REQUEST FOR INFORMATION **DATE:** January 04, 2017 **NO.:** RFI-396

Project Name: 15051-Webster University Interdisciplinary Science Building Project No.: 15051

Subject: Layout of teaching walls based off of grid lines

1 LEVEL 03 AREA A - NORTH FLOOR PLAN
1/8" = 1'-0"

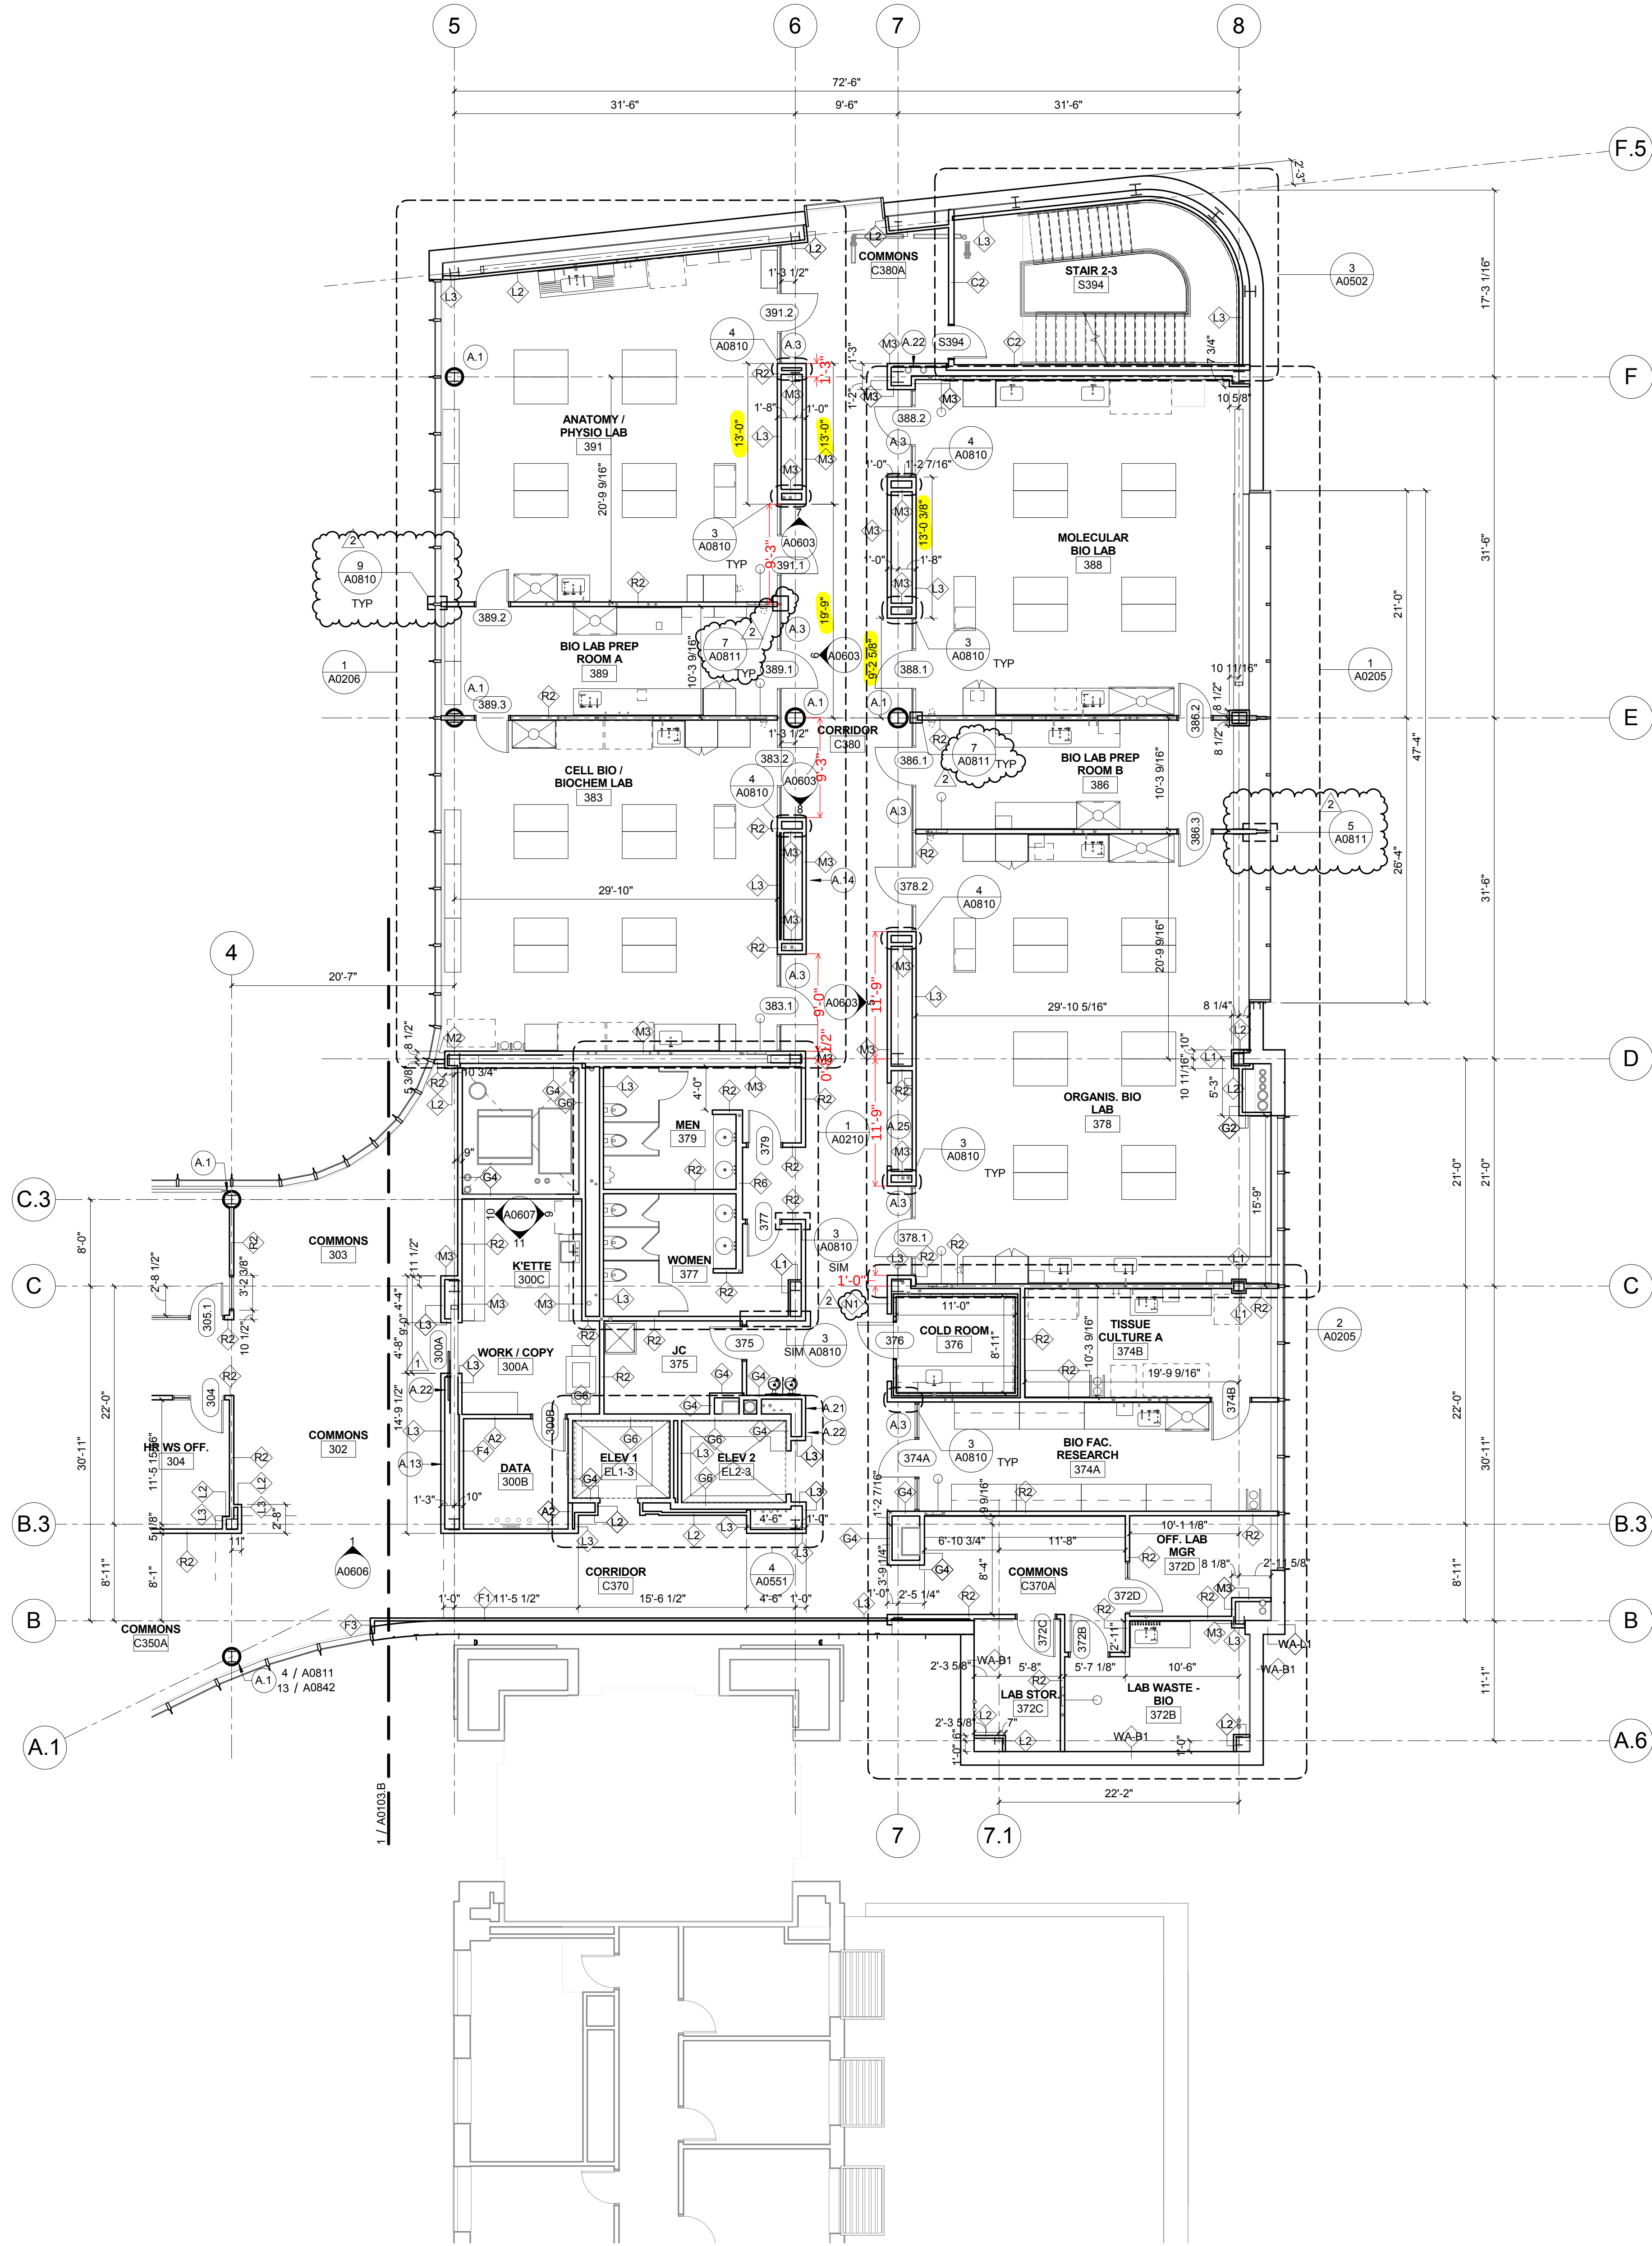
Please provide North/South dimensions for the teaching walls shown in the following rooms

383
391 (or confirm the north face of wall is 1'-3" north of F line) YES
388
383
378
491
488
483
480
472

Please confirm if the ^{1'-8"}~~4'-9"~~ and 1'0" dimensions given east and west from gridlines 6 and 7 are typical at all locations.

YES. EXCEPT AT ROOM 378 DUE TO AQUARIUM - MIGHT MOVE EAST TO ACCOMMODATE A WIDER TANK AND ROOM 472.

SEE ATTACHED MARKUPS.
